City of Canby

Staff Report File #: DR 20-02 / PAR 20-02 – Baker Center

HEARING DATE: August 10, 2020

Applicant Request

LANDSCAPE PLAN

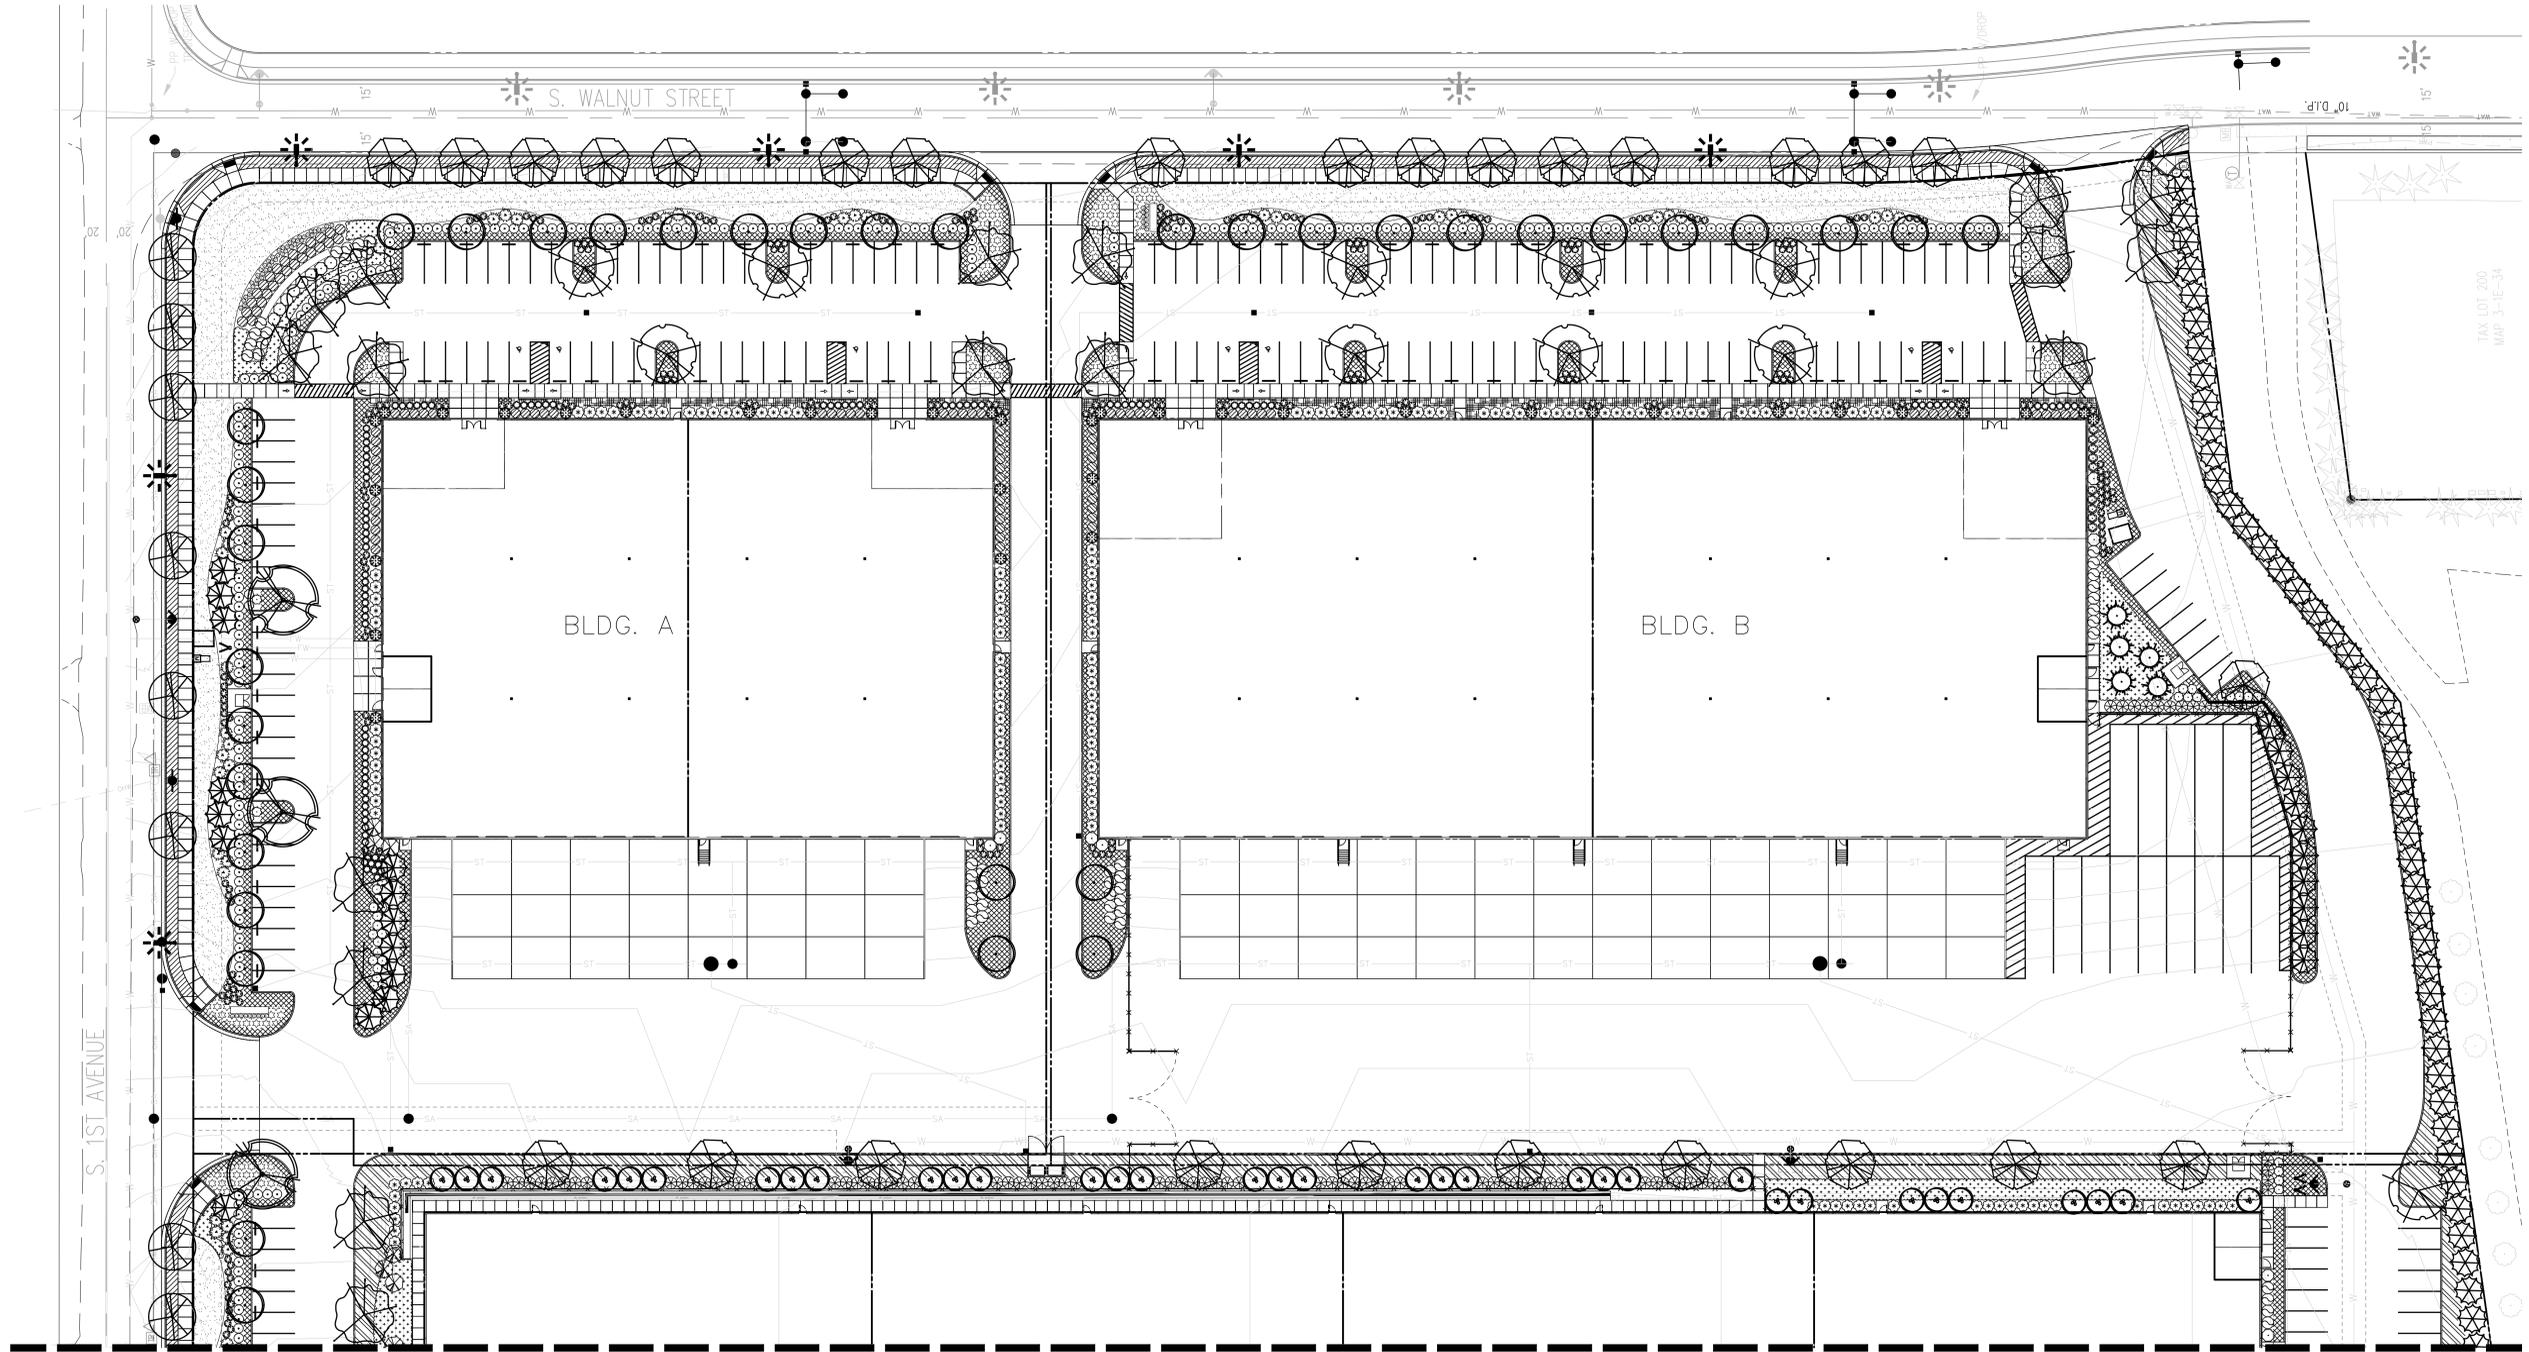
As shown in the submitted Landscape Plan, the proposed project would have layered landscaping along its two street frontages, include street trees in the planter strip and a combination of trees, bushes, and other plantings between the sidewalk and parking areas. This is consistent with Subsection 16.49.120 (G) of the Municipal Code, which states that “screening of parking and loading areas is required.”

44. Prior to occupancy of the facility, all landscaping plant material indicated on the submitted landscape plan shall either be installed and irrigated as proposed, or sufficient security (bonding, escrow, etc.) shall be provided pursuant to the provisions of CMC 16.49.100 (B). The applicant should be aware that the City street tree fee is now \$250 per tree if planted by the City, and the City recommends submittal of a separate Street Tree Plan to assist in the location, species, and total tree count. (R. Potter)
